Title
BLOCK 03/04 ELEVATIONS 1/2

Drawing number
A013

Project
COUNTRY FLATS, SANDFIELDS

DESIGN CHANGES

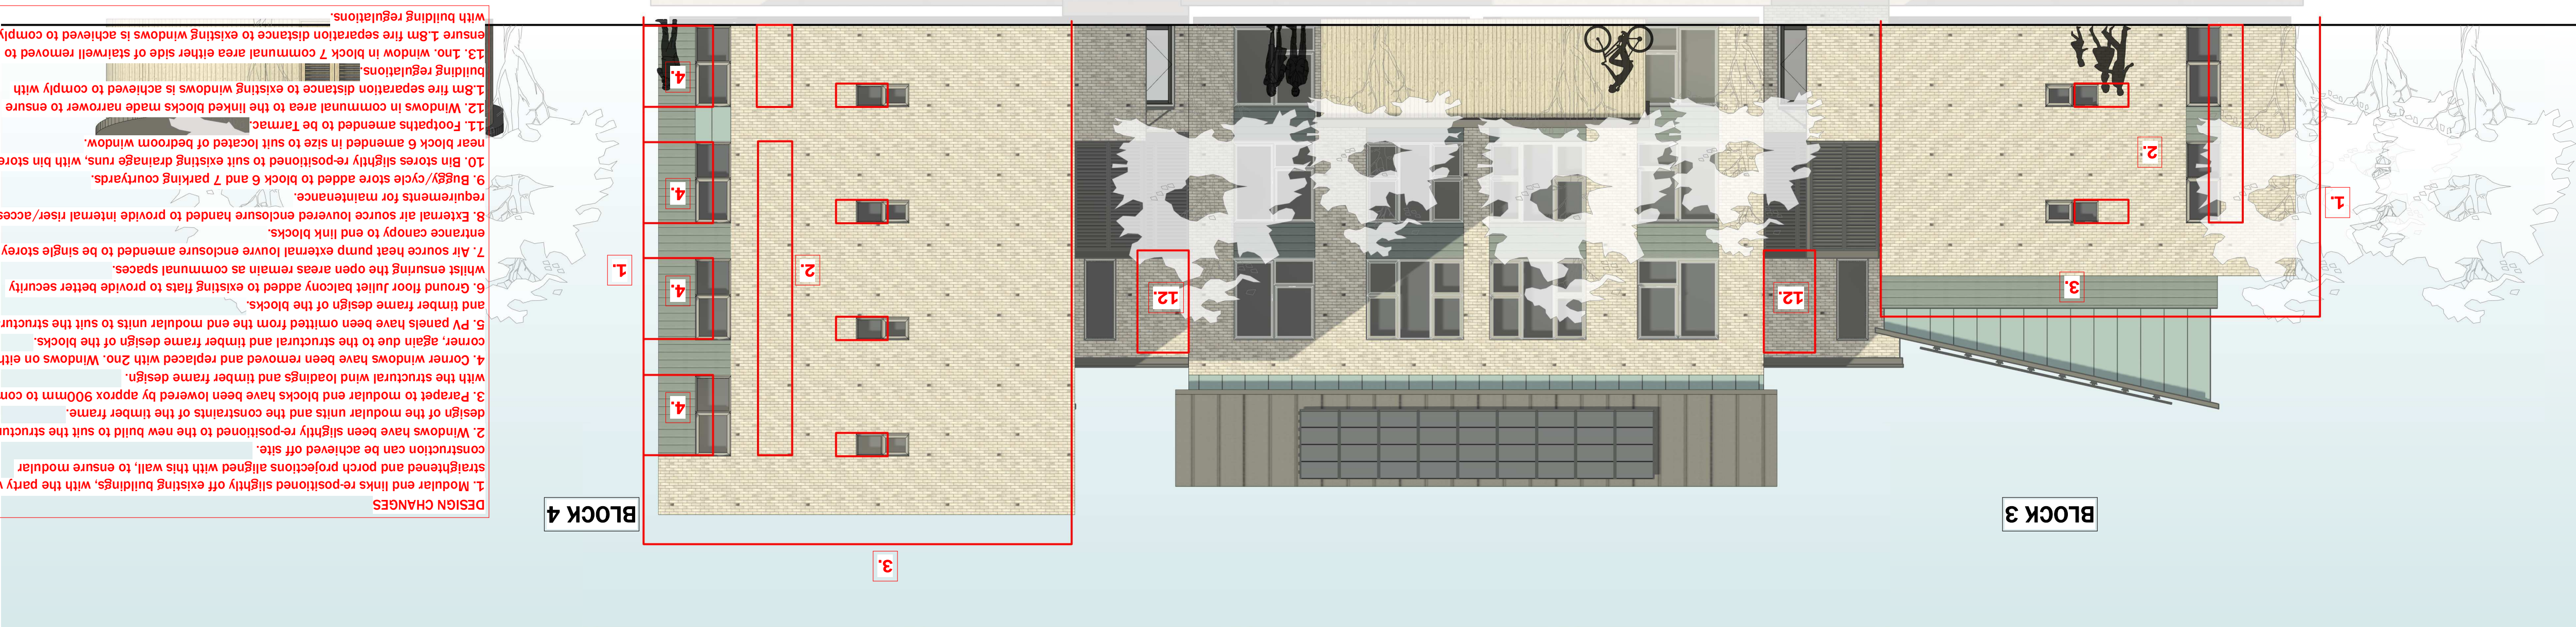
1. Modular end links re-positioned slightly off existing buildings, with the party wall strengthened and porch projections aligned with this wall, to ensure modular construction can be achieved off site.

2. Windows have been slightly re-positioned to the new build to suit the structural design of the modular units and the constraints of the timber frame.

3. Parapet to modular end blocks have been lowered by approx 900mm to comply with the structural wind loadings and timber frame design.

4. Corner windows have been removed and replaced with 2no. Windows on either corner, again due to the structural and timber frame design of the blocks.

5. PV panels have been omitted from the end modular units to suit the structural and timber frame design of the blocks.

6. Ground floor Juliet balcony added to existing flats to provide better security whilst ensuring the open areas remain as communal spaces.

7. Air source heat pump external louvre enclosure amended to be single storey over entrance canopy to end link blocks.

8. External air source louvered enclosure handed to provide internal riser/ accesses requirements for maintenance.

12. Windows in communal area to the linked blocks made narrower to ensure building regulations.

13. 2no. window in block 7 communal area either side of stairwell removed to ensure 1.5m fire separation distance to existing windows is achieved to comply with building regulations.
